CALIFORNIA COASTAL COMMISSION

April 19, 1996

SUBJECT: CITY of CARPINTERIA, LOCAL COASTAL PROGRAM
MAJOR AMENDMENT NO. 1-95, to incorporate into the certified LCP the
Carpinteria Bluffs Coastal Access, Recreation, and Open Space Master Program,
a component of the LCP Implementation Plan. The Master Program will replace
those portions of the City's certified Coastal Recreation and Access
Implementation Plan applicable to the Carpinteria Bluffs only.

STAFF RECOMMENDATION: Certification if Modified as Suggested

Figure 6

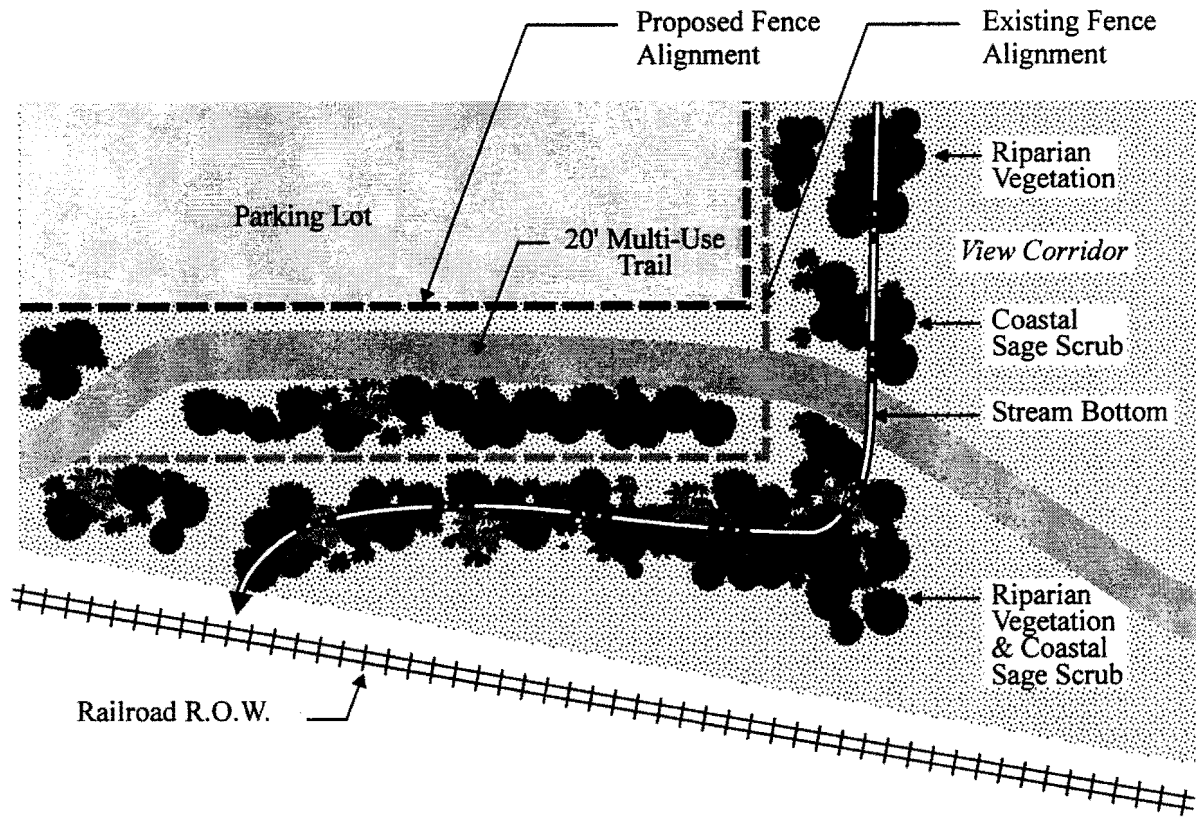
8. A blufftop trail shall be developed along the preferred alignment illustrated in Figure 6. The horizontal portion of the alternative alignment shown on Figure 6, along Carpinteria Avenue, shall be constructed only if the City of Carpinteria fails to obtain the necessary easements to construct the preferred alignment. Dedication of easements to construct the alternative alignment shall be required of all development proposals through which the alternative alignment passes until or unless the preferred railway has been constructed and opened for public use.

12. A blufftop trail with a minimum width of 20 feet shall be developed along the alignment illustrated in Figure 6.

13. Provisions for public parking for shoreline users shall be made within the southerly extension of the alignment of State Route 150 as illustrated in Figure 6. In addition, provisions for parking for shoreline users shall be made within the visitor resort. A minimum of fifteen (15) parking spaces shall be provided adjacent to the designated view-oriented park, including a minimum of two (2) handicapped access parking spaces. No fees shall be charged for the public use of these parking spaces. A minimum of ten (10) public access parking spaces shall be provided at no charge within the upper tier resort parking area adjacent to the easternmost designated view point in Bluffs Area III. At least one of these shall be designated for handicapped access parking. Coastal Access parking spaces shall be provided in addition to such other requirements for the provision of parking that may be imposed upon the development. The upper tier public vista point shall be accessible from the upper tier coastal access parking area within the resort. The corridor between the upper tier coastal access parking area and the upper tier vista point shall be designed to Americans With Disability Act standards. Public access parking within the resort parking area shall be clearly posted with signs reserving these spaces for coastal access parking only and prohibiting the use of these spaces by resort patrons. The main signage of the resort hotel shall include clearly visible notice of the availability of public

14. An open space access corridor connecting Carpinteria Avenue with the bluffs trail and park shall be provided in conjunction with trail development along the southerly extension of the State Route 150 interchange with U.S. 101 as illustrated in Figure 6. The access corridor shall contain a connector trail to the main blufftop trailway, park and vista point and shall be constructed to Americans With Disability Act standards. The open space access corridor shall be landscaped exclusively with locally-native, coastal bluff scrub species. Lighting in the access corridor shall be restricted to the connector trail, shall be shielded from nearby sensitive habitat areas, shall be directed downward, and shall be minimized to be less than 0.01 foot-candles at a distance of five feet from the trail; otherwise, lighting shall not be permitted in the access corridor. Non-pedestrian use of the open space access corridor shall be strictly limited to the connector trail and warning signage shall be posted.

16. A second vista point, including benches, trash receptacles, and bicycle racks, shall be provided in the upper portion of Area III along the bluff edge overlooking the ocean. Although illustrated in Figure 6, the specific location of this vista point will be determined during the site plan review process for Area III. The final selection of a vista point shall be determined on the basis of providing optimal public access to the expansive coastal vistas available at this location. Benches and other amenities at the upper tier vista point shall be accessible from the upper tier coastal access parking area within the resort. The corridor between the upper tier parking area and the upper tier vista point shall be designed to Americans With Disability Act standards. It is intended that this easterly vista point be privately developed and maintained as part of the adjacent visitor-serving resort, but that it remain accessible to the public.

Figure 7

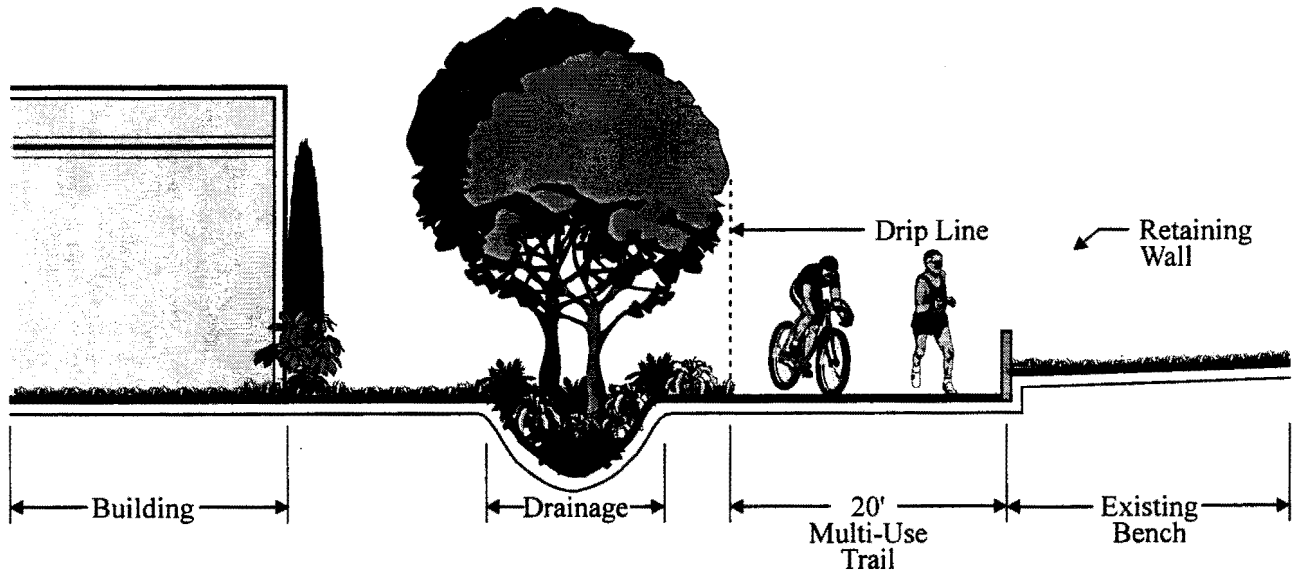
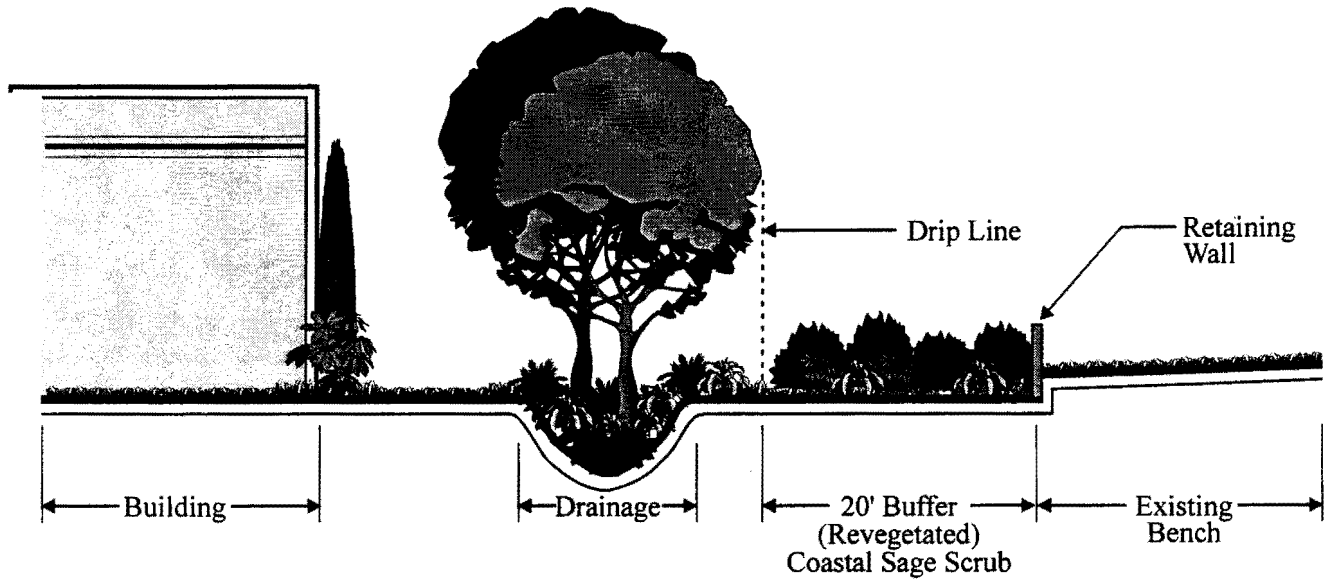
- The trail shall have a minimum width of 20 feet except for the alternative alignment along the east edge of the riparian corridor, where the trail shall have a minimum width of 12 feet (Figure 7). ~~The trail adjacent to the riparian corridor would function as a vertical access if the bluff top trail is constructed concurrent with construction of Line K.~~ The trail adjacent to the riparian corridor shall be deleted from the Master Program if the preferred route is constructed, and the twenty-foot setback buffer from the riparian vegetation driplines shall be restored with suitable, locally-native riparian and coastal sage scrub species.

Modification 7 contains provisions to ensure that if the alternative bike/trail route is not constructed, the setbacks from designated habitat would be restored with locally-native riparian and coastal sage scrub species.
